PCN:	GT 150 FEMALE SN SEALED localization

Date:	October 26,2026

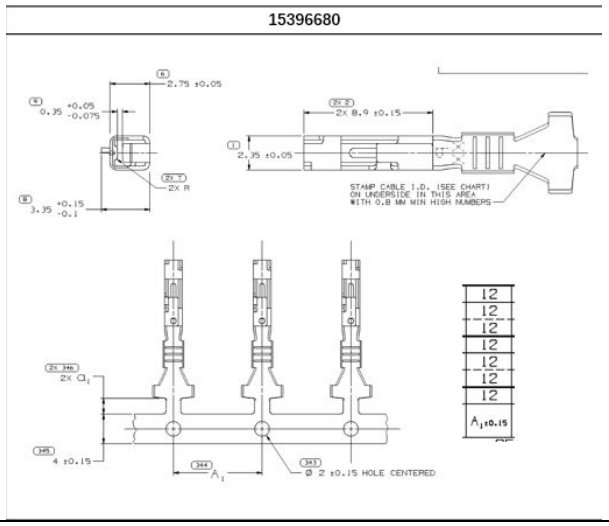
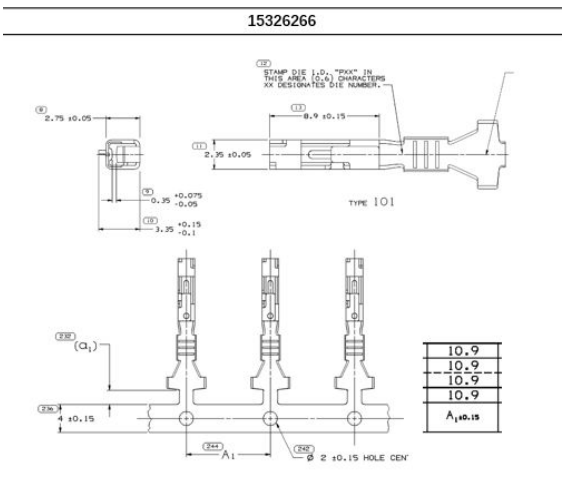
Description :	DCS Shanghai Plant has completed GT 150 SN SEALED localization. Domestic PN is 15326266.
Assessment of Change:	Terminal body dimensions are completely identical, spacing of the terminal reels is different,15396680 is 12mm,15326266 is 10.9mm.

15396680	15326266

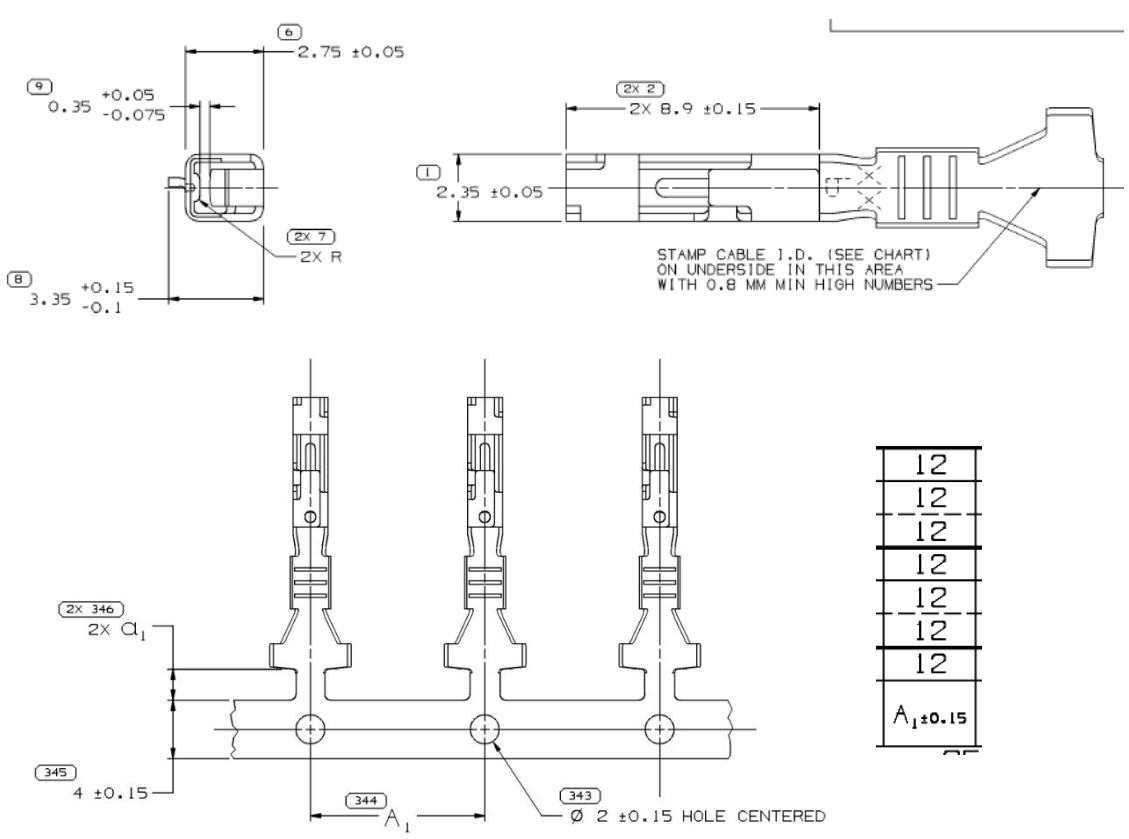
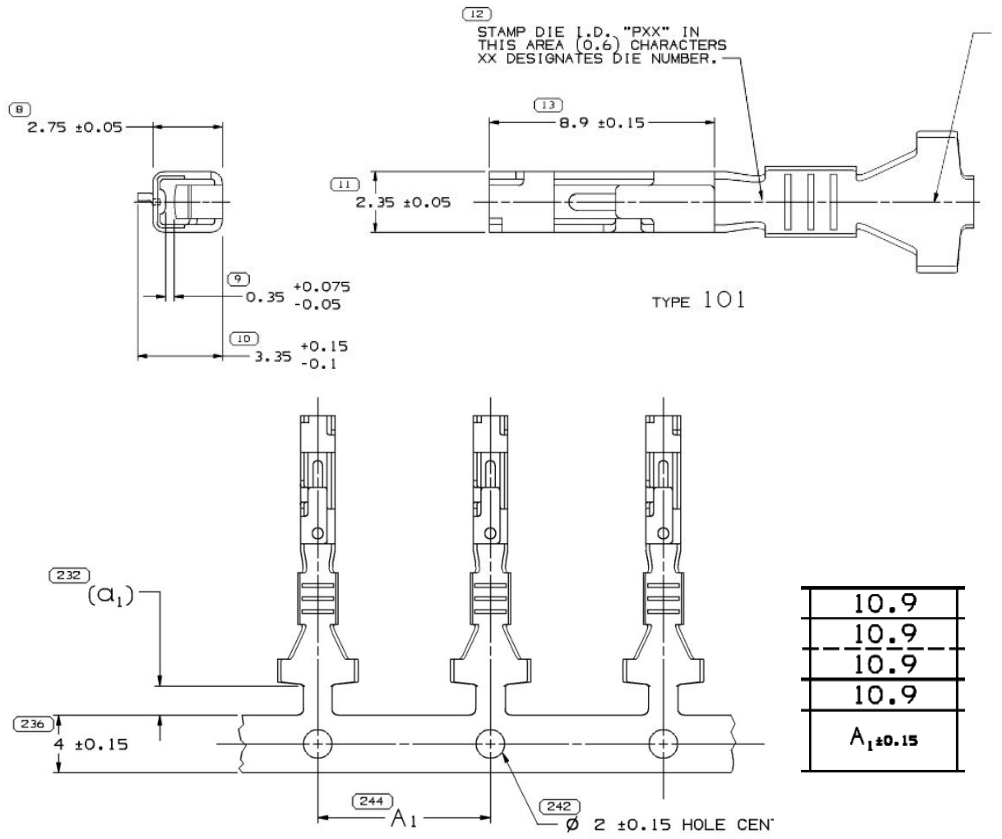
端子本体尺寸完全相同，唯一区别是端子绕盘间隔不同，一个是12mm，一个是10.9mm
